Dewberry Response to USGS Review of the FEMA IX - Orange County, CA LiDAR Processing Project

Produced for U.S. Geological Survey

USGS Contract: G10PC00013

Task Order:G12PD00039

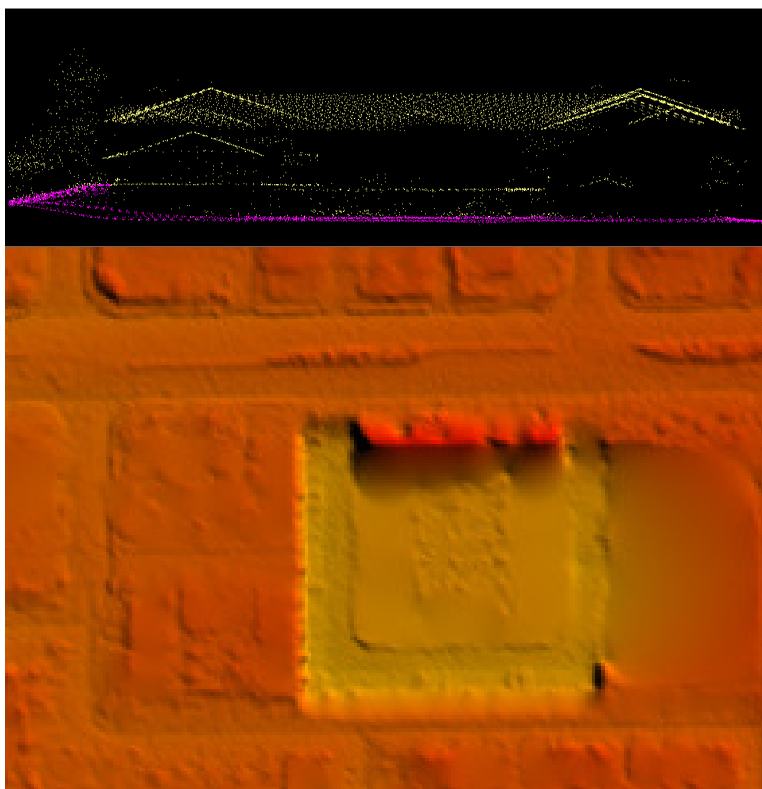
There were eleven locations where comments were made to remove structure related artifacts. The DEM surface models are created from terrains. Terrain models create continuous surfaces from the inputs, in this instance LiDAR ground points. The surface model must make a continuous model and in order to do so, points are connected through interpolation. This can cause visual artifacts in areas where the ground elevation is higher on one side of the building than the other. This is common throughout California where many homes are built into hillsides. As these “artifacts” are only visual and do not exist in the LiDAR points, no modifications were made to the LAS or DEMs in 10 of these areas. Modifications were made to 1 area where highpoints could be removed from the ground to create a cleaner surface model. Examples are shown below.

Figure 2 - Tile 11SMT096435. The DEM in the bottom view shows a visual artifact because the surface model is interpolating between the available ground points on either side of the building points that were removed. The profile in the top view shows the LiDAR points of this particular feature colored by class. All building points have been removed from ground (pink) and are unclassified (yellow). There are no ground points that can be modified to correct this visual artifact.

Figure 13 - Tile 11SMT081240. At the time of LiDAR acquisition, this area was under construction and dirt hills were present as shown in the top view. At the request of USGS, these hills have been removed from the ground as shown in the redelivered DEM in the bottom view.

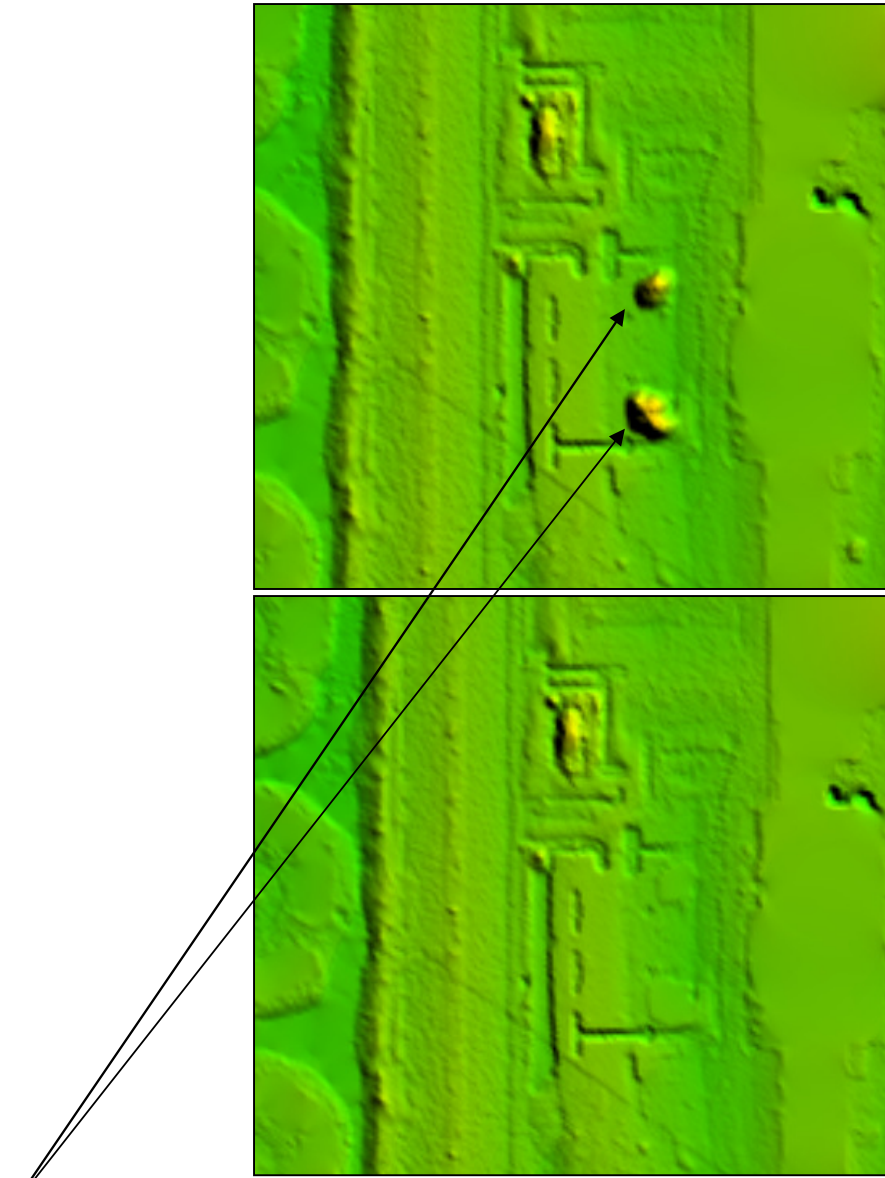
There were three calls to remove features from the ground surface. Dewberry removed the identified features as requested by USGS. Examples are shown below.

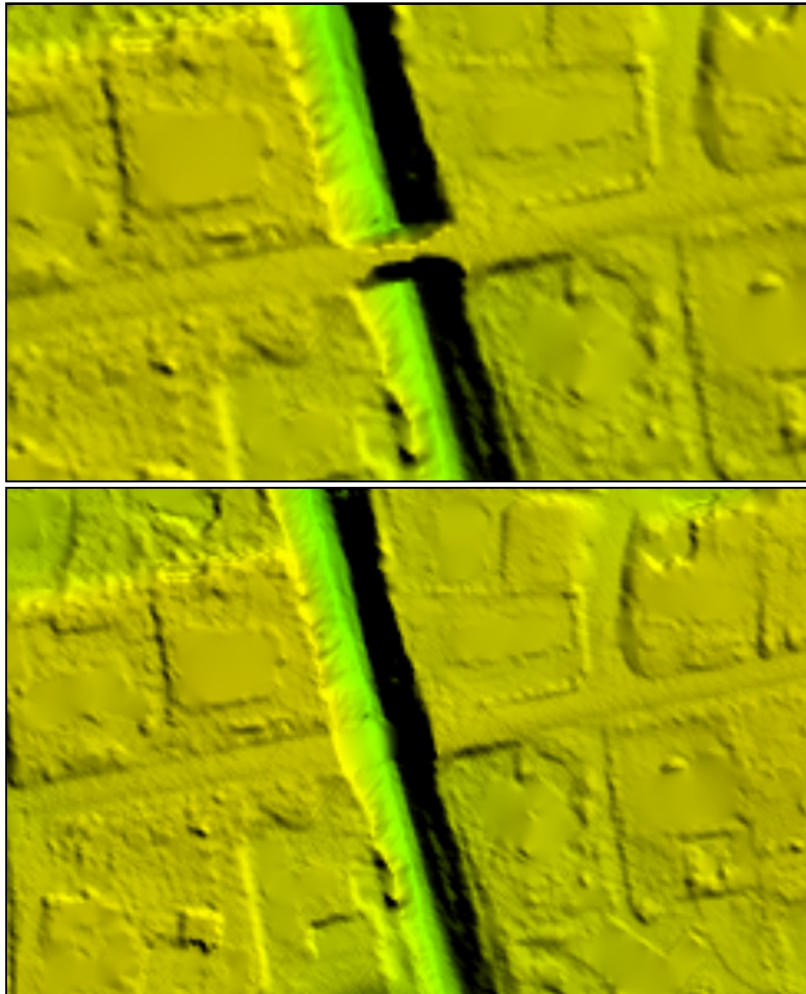
There were two locations where Dewberry interpreted a feature as a culvert and included it in the ground surface. USGS identified these features as bridges, not culverts. Dewberry has modified the points and removed these features from the ground surface. Examples are shown below.

Figure 15 - Tile 11SMT126525. The feature identified was originally interpreted as a culvert and included in the ground surface as shown in the top view. USGS identified this feature as a bridge. The LAS and DEM have been corrected by removing this feature from the ground surface as shown in the bottom view.

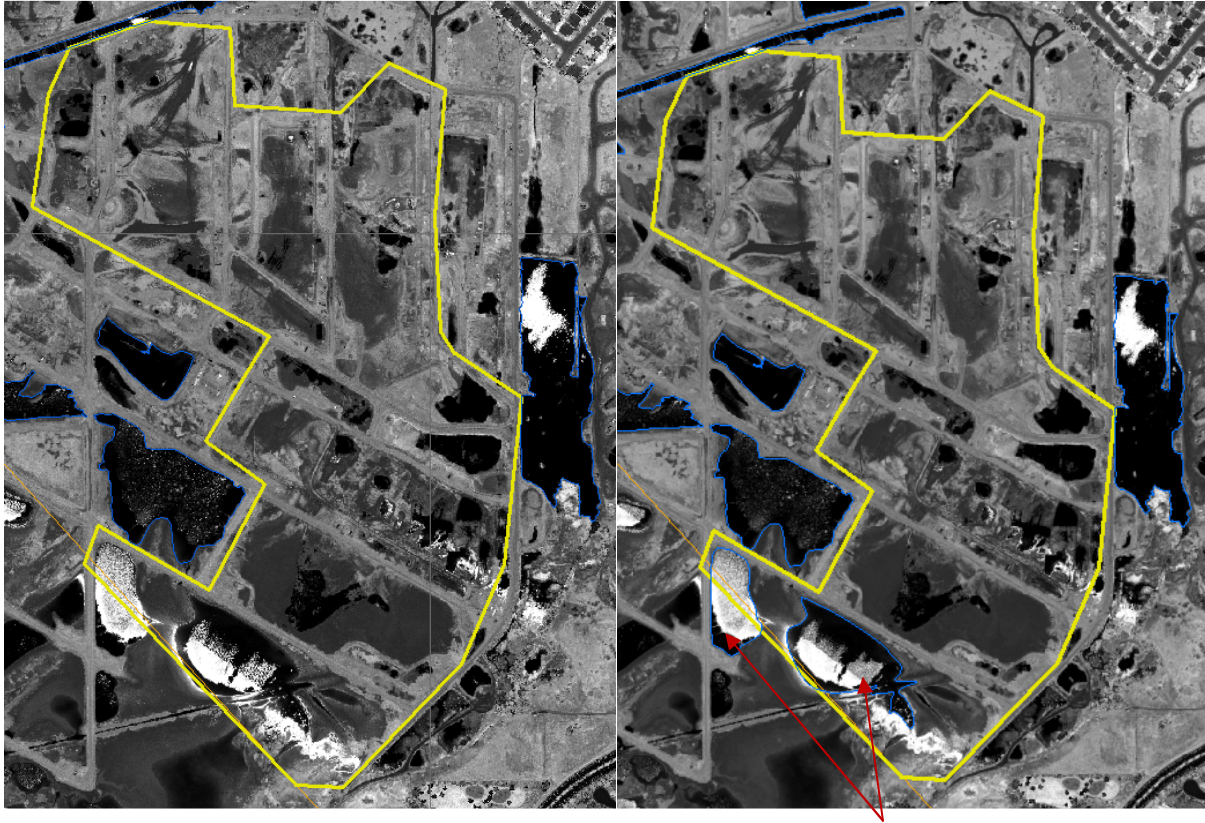
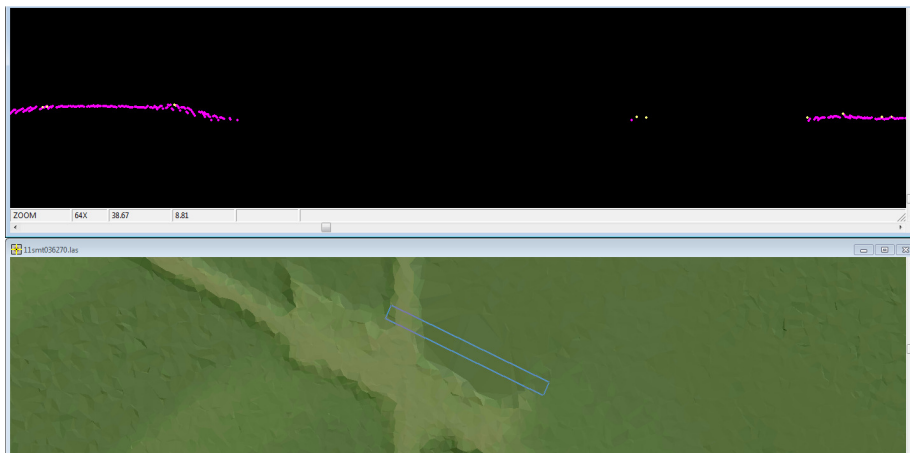
There were four locations where USGS identified areas of water that were not included in the collected breaklines. While the interpretation of the feature may be questionable in the intensity imagery, Dewberry agrees with three of the calls after reviewing color imagery and the available LiDAR points. There is one location called out by USGS where, after reviewing the LiDAR, Dewberry confirmed that the breaklines accurately capture the existing water and no changes were necessary. Examples are shown below.

Figure 17 - Tiles 11SMT036270, 11SMT051270, 11SMT036285, and 11SMT051285: The intensity image showing the collected breaklines from the first delivery is on the left. The modified breaklines from this delivery are shown in the intensity image on the right. Dewberry added two ponds to the delivered breaklines. The LAS and DEMs have been corrected to reflect the addition of these features.

Figure 18 - Tiles 11SMT036270, 11SMT051270, 11SMT036285, and 11SMT051285: The LiDAR points shown above confirm that the breaklines delivered to USGS should be modified to include additional water bodies. The black areas are where no points were returned due to the presence of water. The black areas that are 2 acres or greater and have been confirmed to be water have been added to the breaklines and the LAS and DEMs have been modified to reflect these changes.
